**Perry**

**LICENSEE  
POST-EXAM  
COMMENTS**

SUBJECT: MASTER EXAM(S) AND ANSWER KEY(S) PROPOSED CHANGE

Subject: License Class 99-01 written examination comments

#### 6.4 Reactivity Management

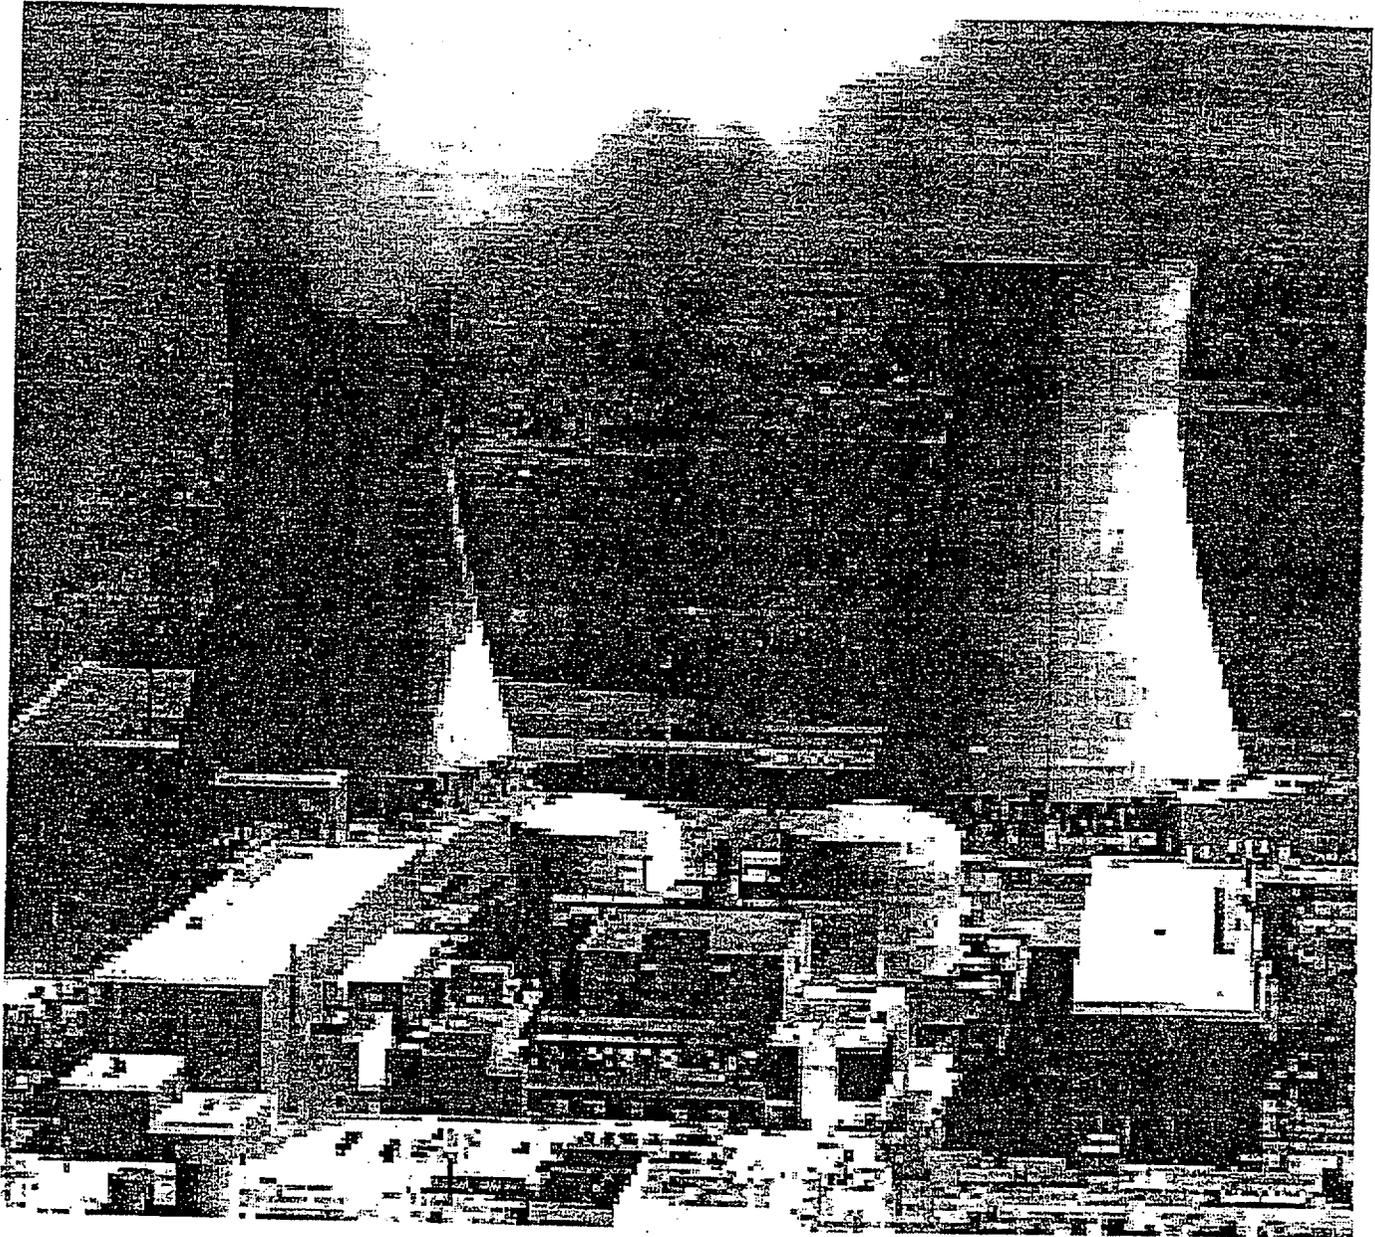
Comments: PAP-0201 requires the ATC operator to shutdown the reactor when a scram setpoint is exceeded. This requires ONI-C71-1 entry leaving a second correct answer of (C). The PEI bases discusses and allows use of other instructions with the PEIs. In this case, ONI-C71-1 entry and use is taught and re-enforced in the student's simulator sessions. C and D are both correct.

#### 14.4 RETURN OF EQUIPMENT AND PLANT SYSTEMS TO SERVICE

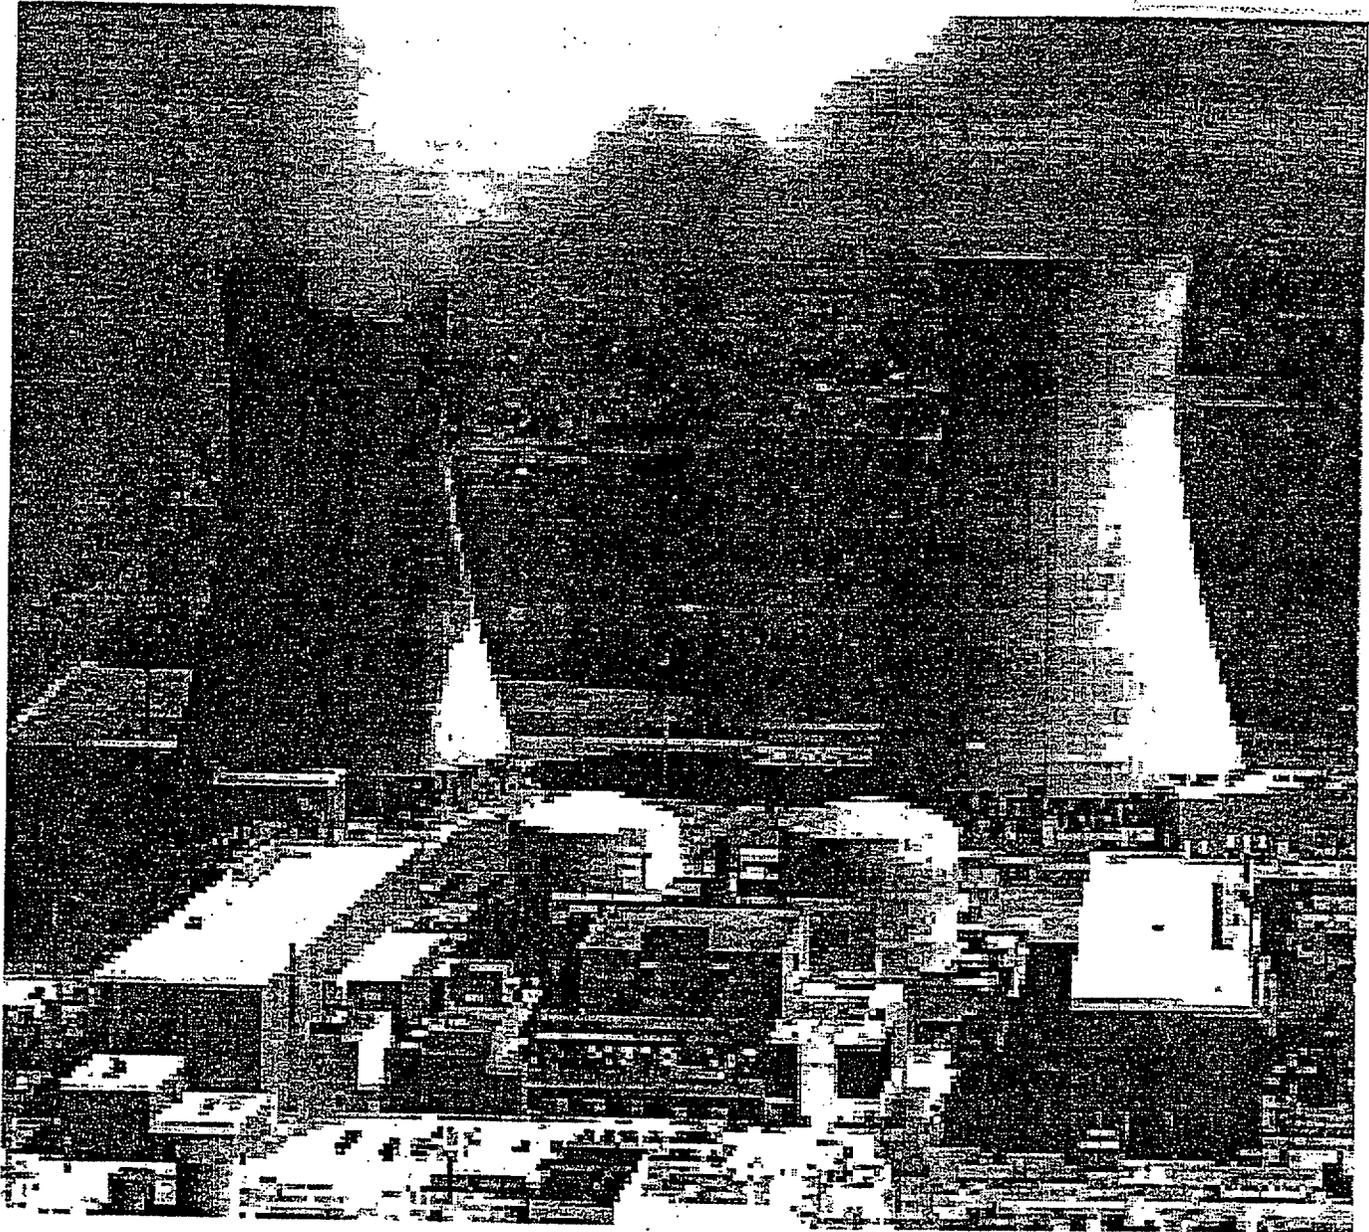
Comments: PAP-0205 allows the US to waive IV for Alara reasons. The correct answer is therefore B, which allows the US to waive the IV when radiation levels exceed 10 mrem. (Prior to December 12th when a PIC on QAP 14 was approved, the US had been directed not to waive the IV requirements in accordance with the Standing Instruction that was used as the original procedure reference for this question.

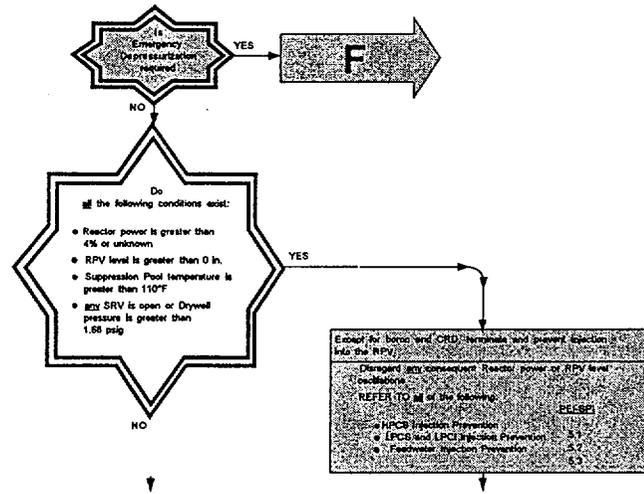
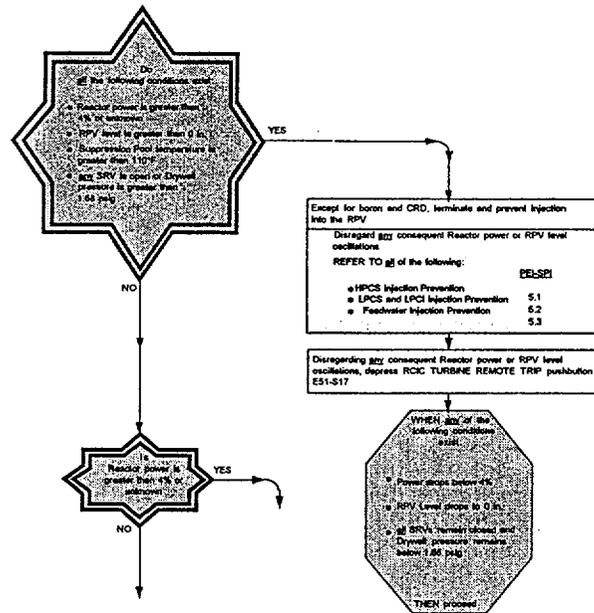
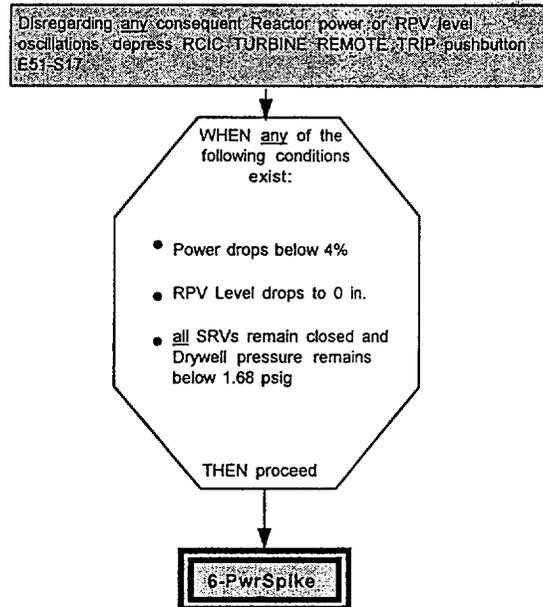
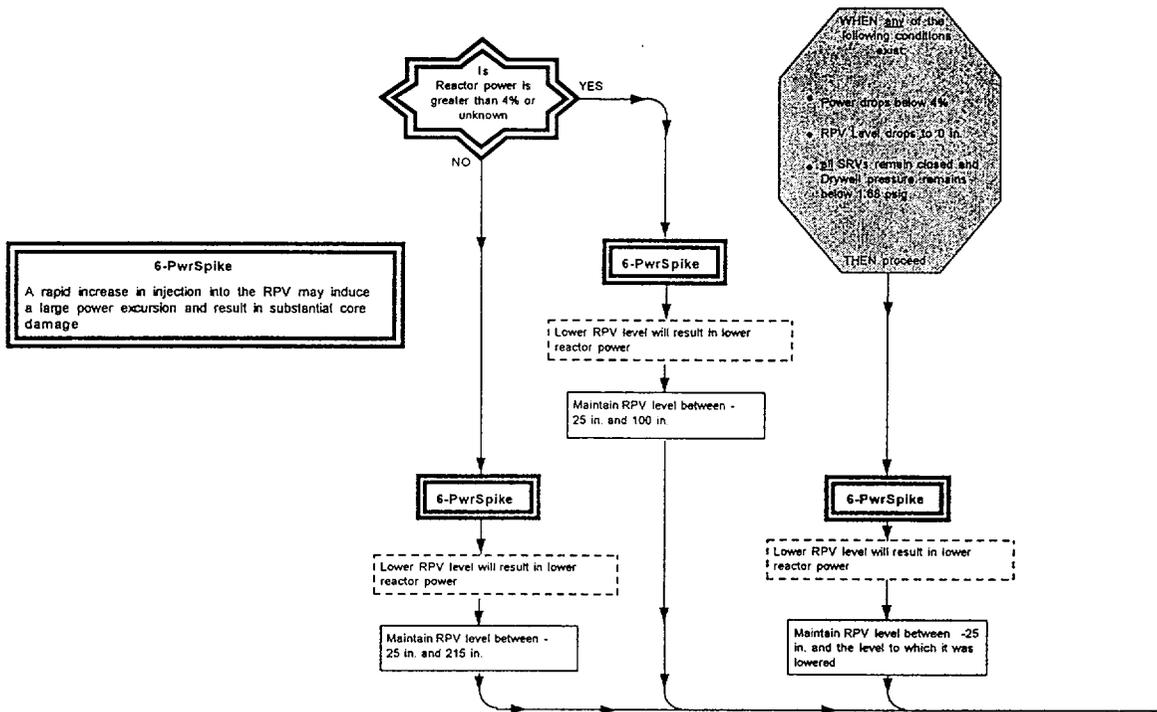
Comments: PEI-B13 flowchart gives -25 to + 100" on conditions greater than 4% power. With level at 115" and reactor power at 10%, level has not been lowered at this point. The last level band given would have been -25 to + 100" thus leaving C as a second correct answer. The student assumes by the information given that he has not met the conditions of the hold step which lowers level and gives as his answer the last possible level band. C and D are both correct.
